RESOURCE CONSENT RMA/2022/3611 – RFI RESPONSE LAND USE AND SUBDIVISION APPLICATION 320 AND 320A CUMNOR TERRACE, CHRISTCHURCH

1. This letter responds to the further information Council requested on 18 January 2023 in respect of the above resource consent application.
2. The following response is organised under the same headings with the items reproduced in grey text.

APPENDIX 1 - LANDSCAPE RFI PORTLINK INDUSTRIAL SUBDIVISION

Client / project name: BRAEBURN PROPERTIES- PORTLINK SUBDIVISION
 Drawing name: BUND CROSS SECTION B-B
 Designed by: CG
 Drawn by: CG/ NK
 Original issue date: 23 MARCH 2023
 Scale: 1:100

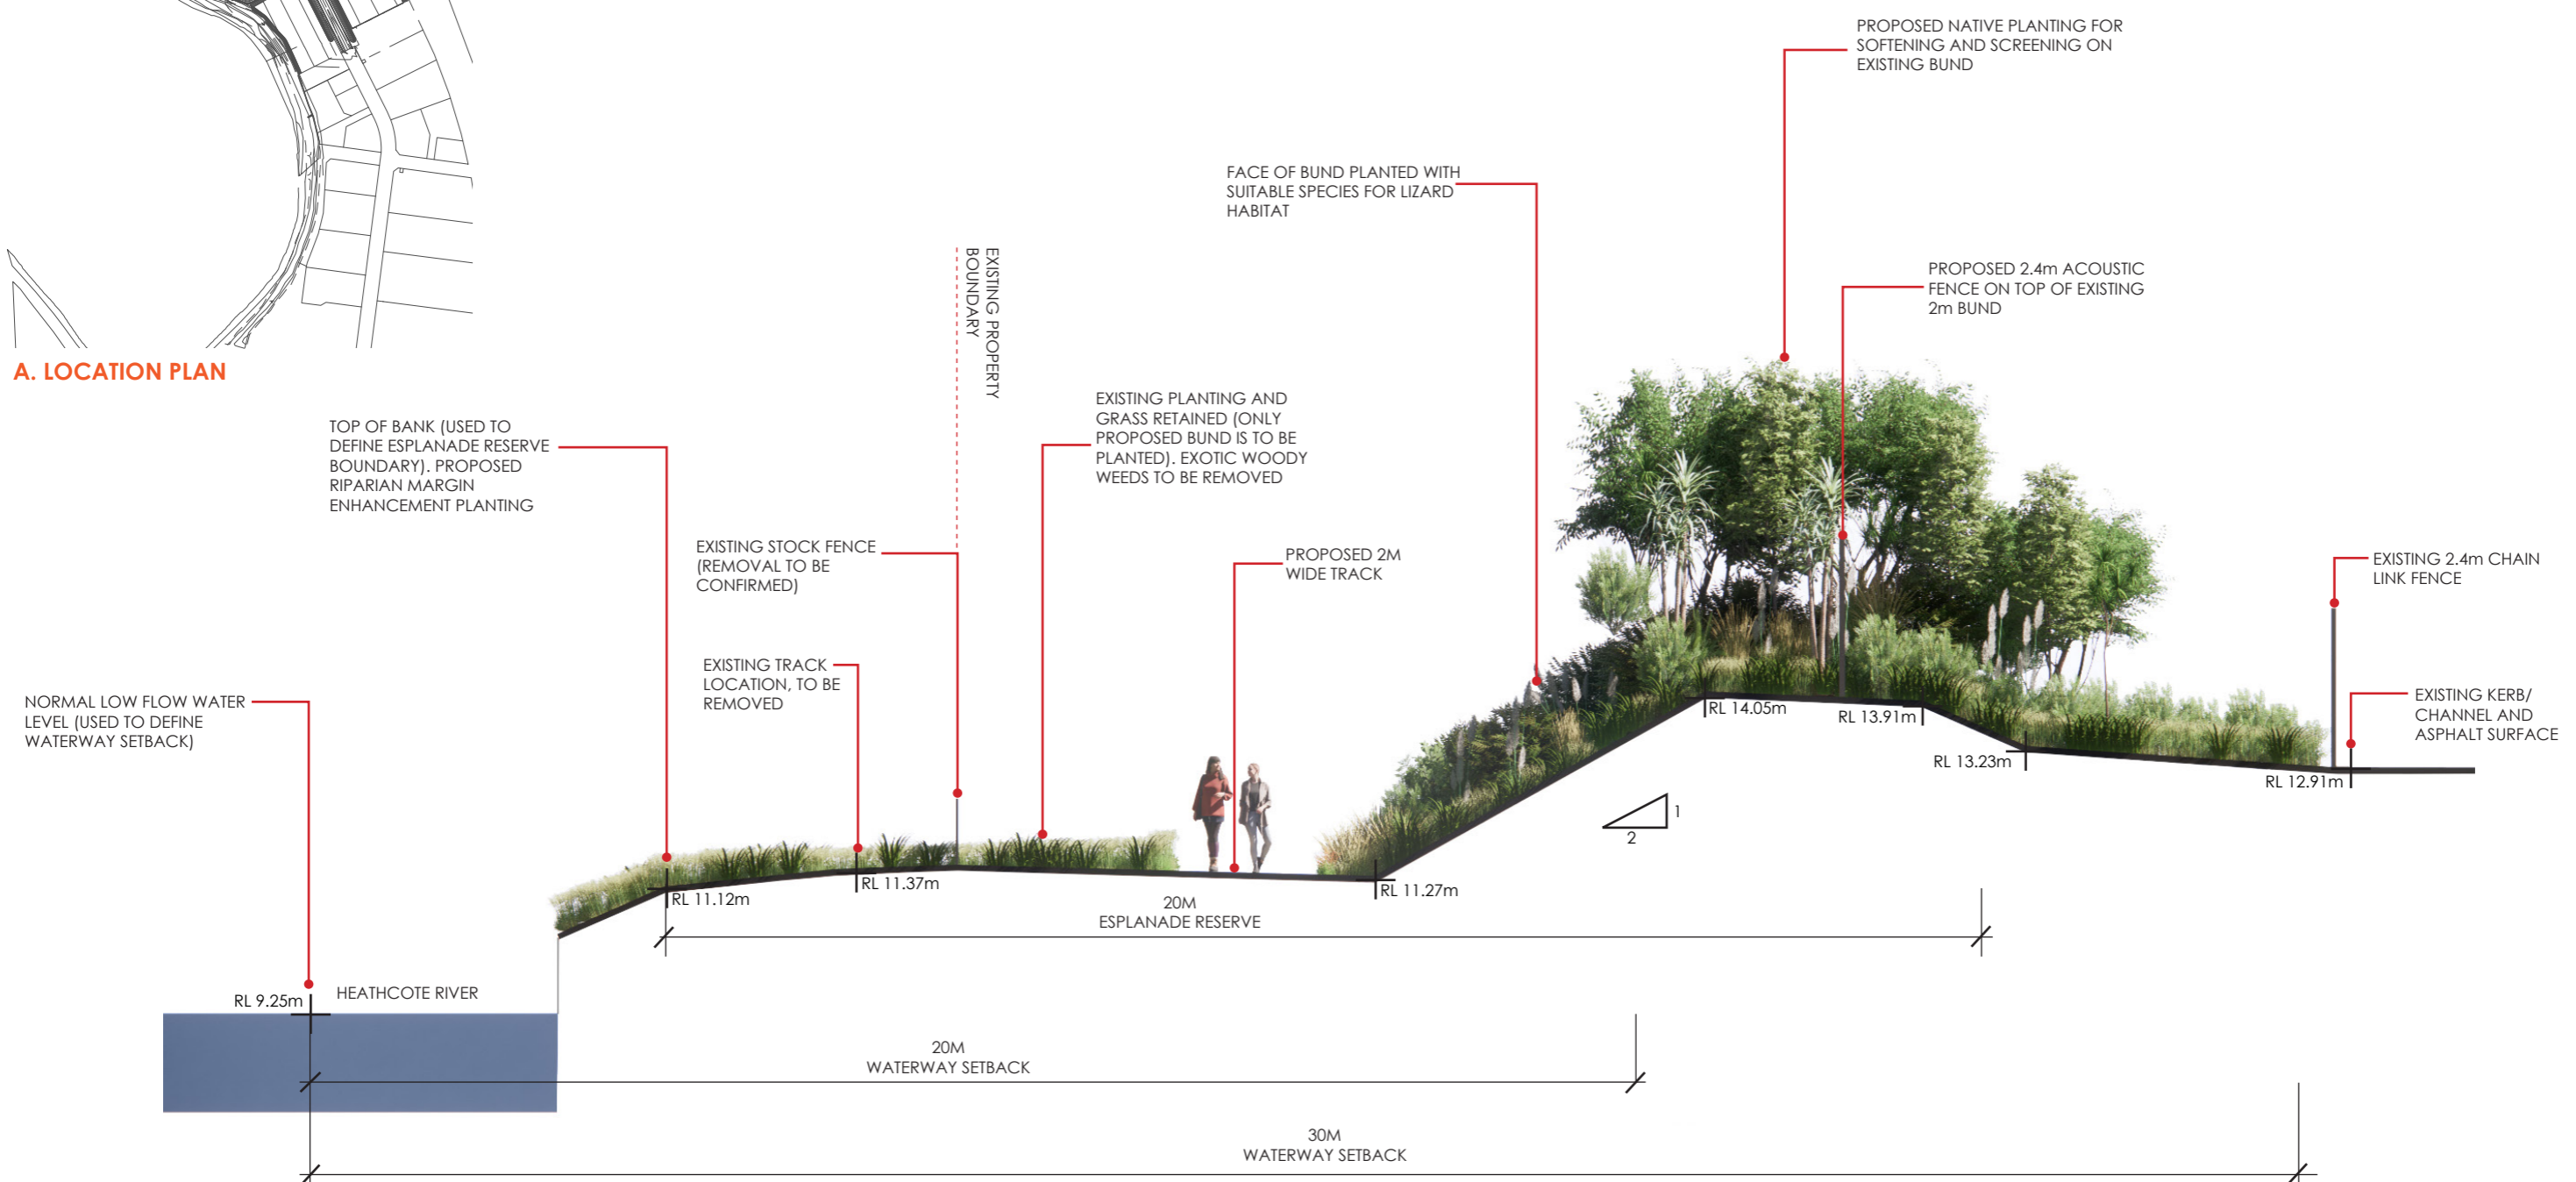
- *Please illustrate existing topographical levels and features, and finished levels on the cross section and confirm that it is to scale. The existing cross section implies a flat topography and gradients to the bund are inconsistent with the Woods survey and as-built plans. Key features include boundaries, fences, track, esplanade reserve, waterway setback, locations/levels of low flow/top of bank and relative slopes*
3. Please see **Appendix 1** with scale bar added to the landscape plans. The red dashed line has been confirmed to be consistent with the site boundary as per updated subdivision and as-built survey data.
 4. **Appendix 1** also contains the amended landscape concept plans that includes the requested details including updated cross-sections showing accurate topography / levels,

The northern face of the bund appears to be 1H:1V when on site. Please confirm if this is the case. Please confirm the fill material used to create the northern and southwest bund. Is the material and slope suitable for planting upon?

boundaries / setbacks and other key features. The cross-sections are consistent with updated survey data provided by the surveyor.

5. The north face of the northern bund has a gradient of 2H:1V and the western face of the southwest bund has a gradient of 2H:1V, as confirmed by survey data. In terms of its construction, the core has been formed using recycled concrete left over from site filling. The core is covered with a minimum 300mm layer of topsoil and was grass seeded for stabilisation prior to planting.

Client / project name: BRAEBURN PROPERTIES- PORTLINK SUBDIVISION
 Drawing name: BUND CROSS SECTION C-C
 Designed by: CG
 Drawn by: CG/ NK
 Original issue date: 23 MARCH 2023
 Scale: 1:100

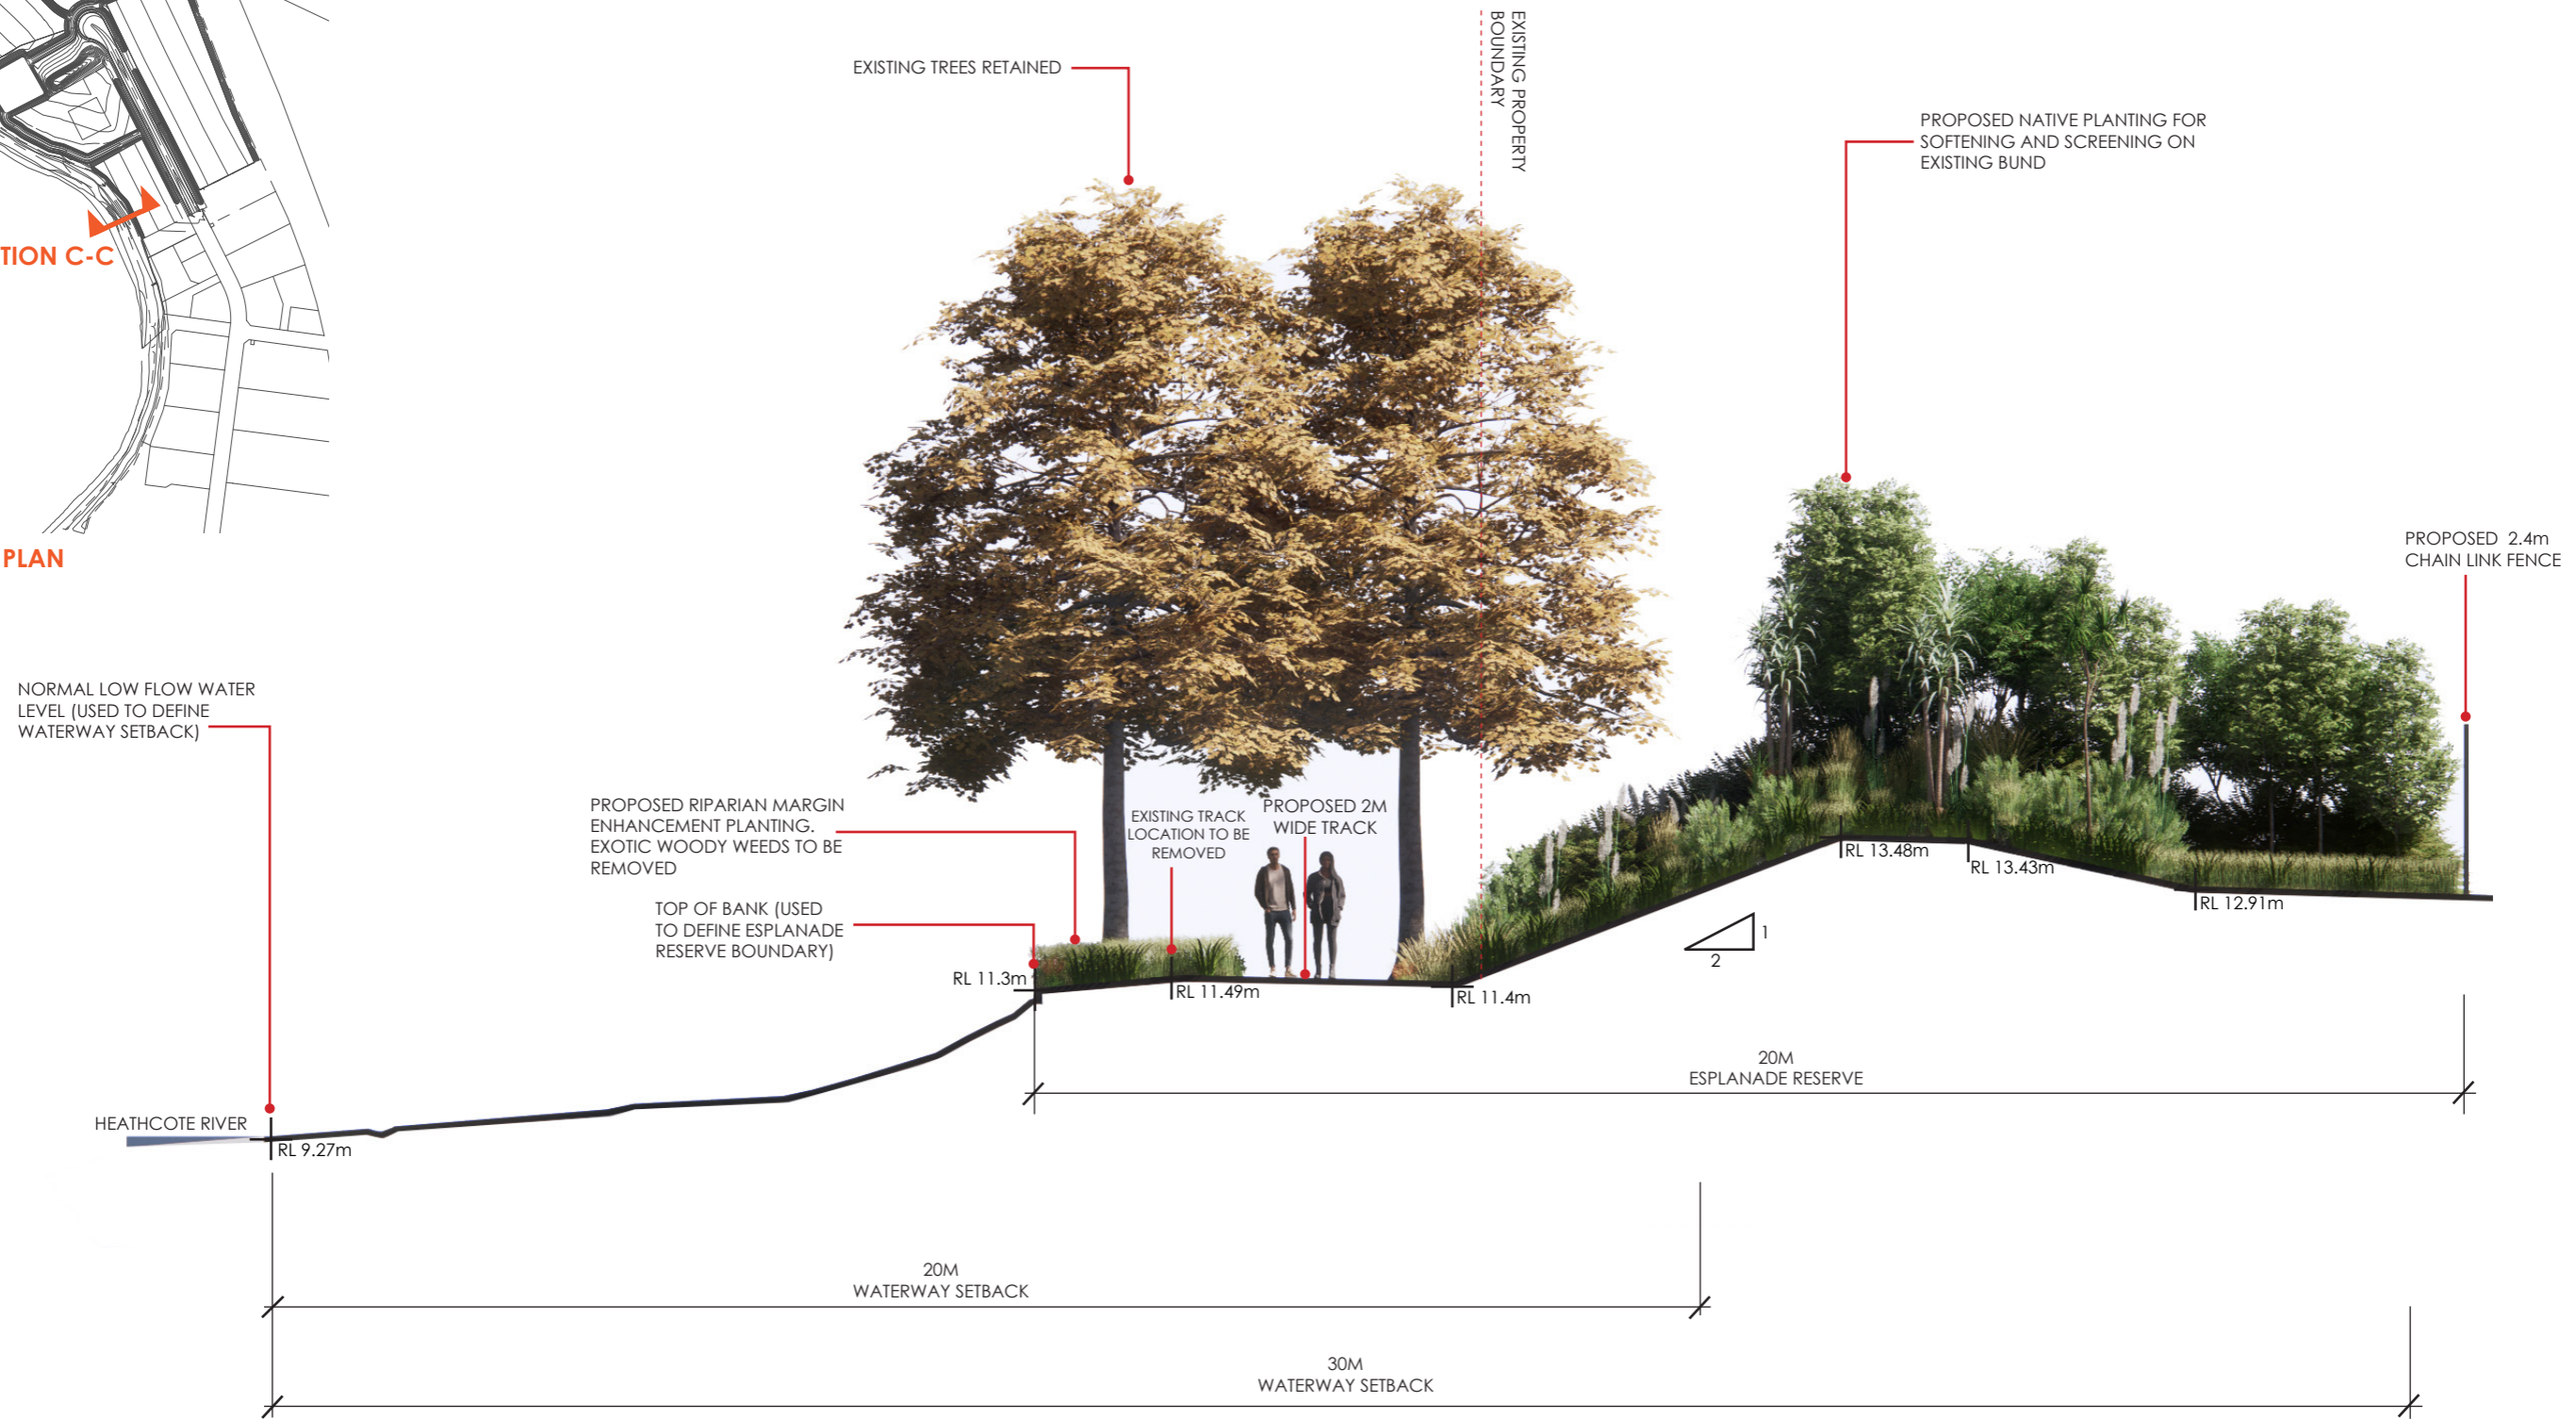
The ground level shown on the north side of the river appears approximately 1.8 m below the site hardstand level. Please confirm the relative levels are correct?

11. The levels have been checked by the surveyor and they have confirmed that levels on the north side of the river range from 1.4 metres to 1.8 metres below the site hardstand level.

Client / project name: BRAEBURN PROPERTIES- PORTLINK SUBDIVISION
 Drawing name: BASELINE/ PROPOSAL SECTION
 Designed by: CG
 Drawn by: CG/ NK
 Original issue date: 23 MARCH 2023
 Scale: 1:600

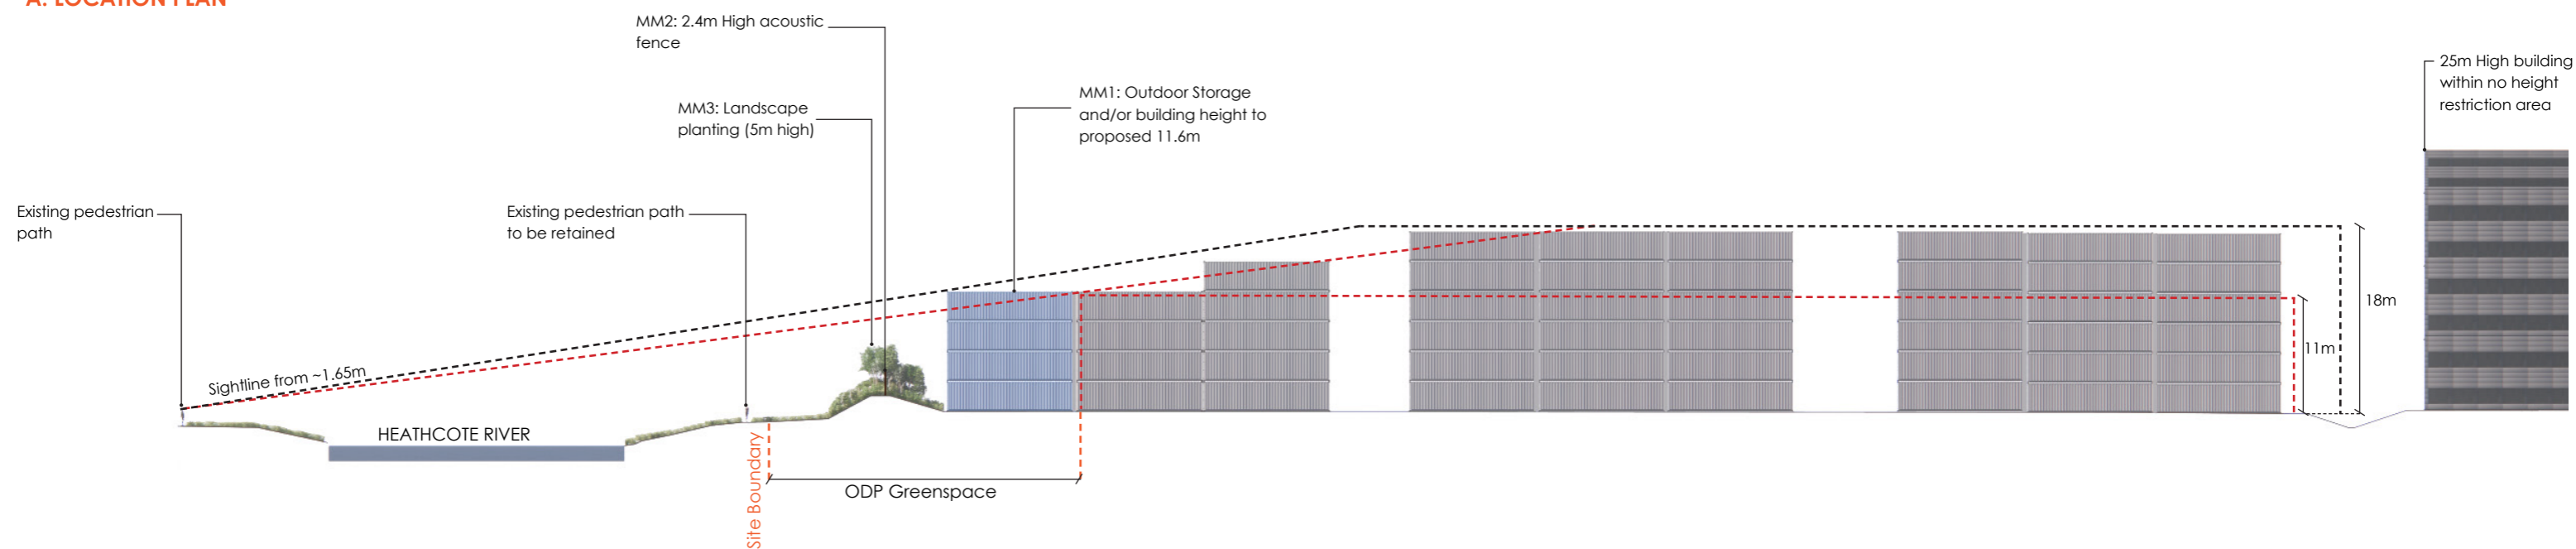
- 3.2 Permitted baseline, second to last paragraph: Please discuss the actual permitted baseline and demonstrate the effects (or lack of effects) on the visibility of skylines and the amenity these landscape features provide primarily for permanent residents of Gould Crescent, but also to the public within the area.

- 3.3 Second paragraph, third to last sentence: This is unclear, please clarify what is meant here.
- 3.3 Second paragraph, second to last sentence: Please clarify what "a similar level of screening is achieved" refers to.

3.2 Permitted Baseline: The permitted baseline is a 11m building height limit area as per the ODP, outside of the ODP Green Space setback. Further into the site, as per the ODP there exists areas not subject to a height restriction, where a 20-25m height building could be constructed. This permitted baseline is considered as having similar visual effects to the proposal in obstructing potential views of the skyline from various viewpoints. The potential visual bulk, height and scale remains comparable.

*3.3 . 'As shown on the cross section in **Appendix 1**, and mentioned above, the use of the sealed encroachment has low visual effects when compared to buildings within the 11m height limit due to the immediate increased height obtained from the bund.'*

To clarify, the encroachment of buildings and outdoor storage into the ODP Green Space is considered to have low visual effects compared with the permitted baseline (buildings with 11m height limit, outside of the Green Space). Width of planting in this case is not considered the primary important factor to achieving adequate screening mitigation of the site. It is the vertical height that is of importance, where the bund provides an immediate screen and elevated height for mitigation planting to achieve a vertically higher and improved level of softening / screening to the bulk appearance of the development, over time as vegetation matures.

Client / project name: BRAEBURN PROPERTIES- PORTLINK SUBDIVISION
 Drawing name: GOULD CRESCENT SECTION
 Designed by: CG
 Drawn by: CG/ NK
 Original issue date: 23 MARCH 2023
 Scale: 1:750

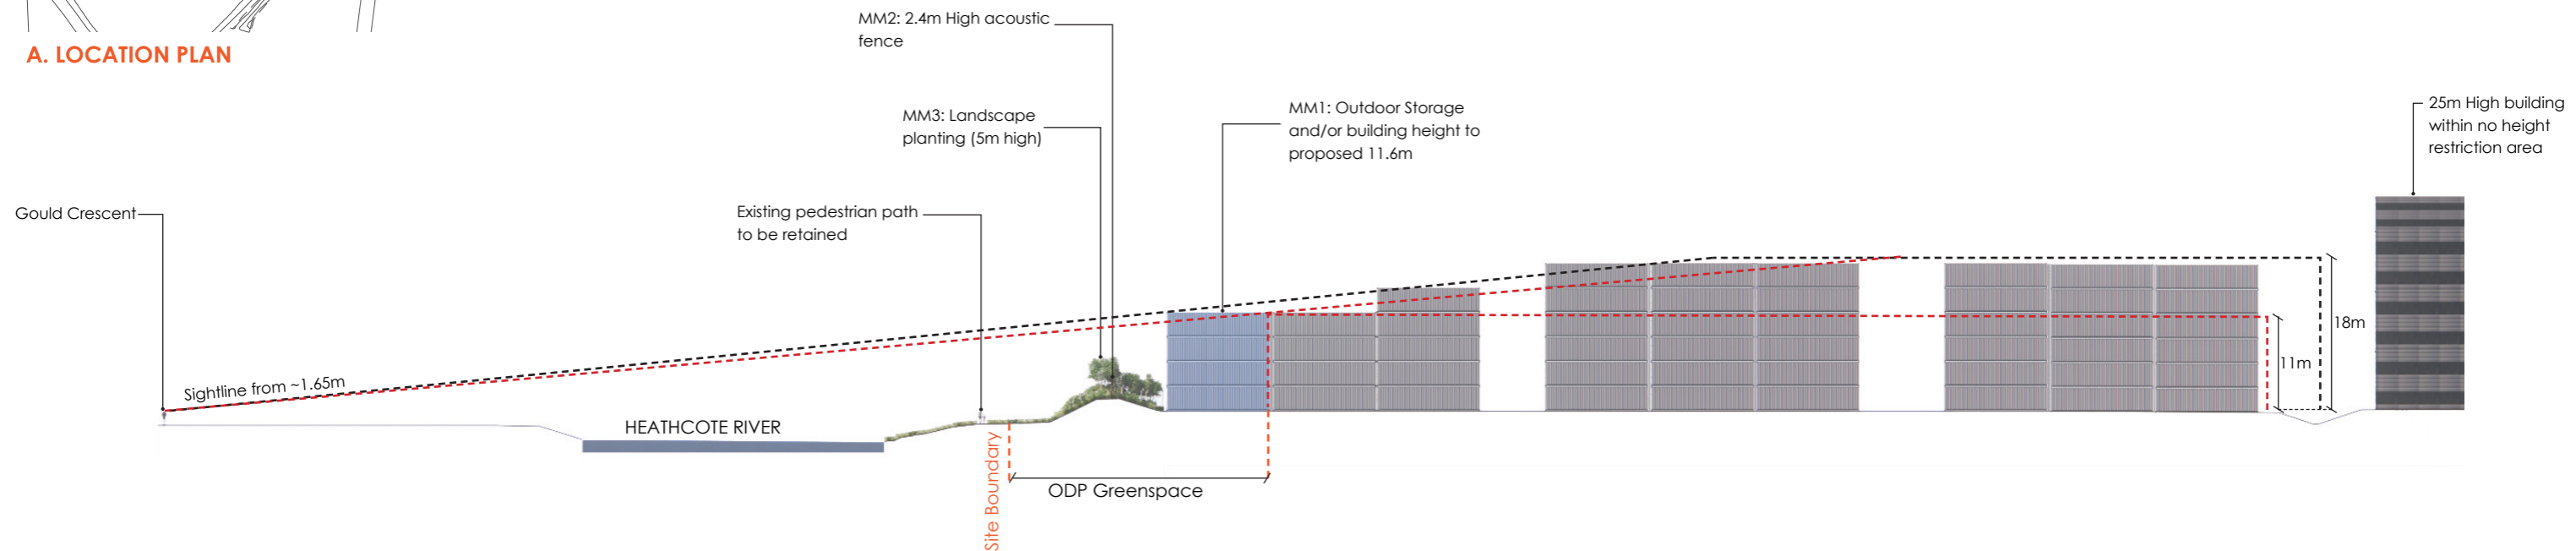
Please provide a sightline diagram and analysis of the effects from further away, such as along parts of Gould Crescent. From here, the sightline will be 'flatter' where more of the proposed containers stacked 11.6 m – 18+ m high will be visible.

12. Please refer to **Appendix 1** for the sightline diagram and below for additional comment from DCM:

The parts of Gould Crescent which are relevant to this sightline are limited to where Gould Crescent runs parallel with the Heathcote River, and where more direct views over the site are available. In assessing this sightline, the view is flatter in angle due the viewer being more distant from the site. From this viewpoint, as assessed previously, the proposed sloping height plane capped at 18m creates no additional visual effects due to the flatter view angle allowing a greater visibility of the part of the site not subject to a height restriction (where a 20-25m height building could be constructed).

The flatter view angle does provide a view over the site which is backdropped by the Port Hills where the built form largely doesn't break the skyline, retaining the ridgeline. While the effectiveness of the proposed mitigation planting is marginally reduced by this flatter view angle, once matured, the vegetation will provide a predominantly 'green' view.
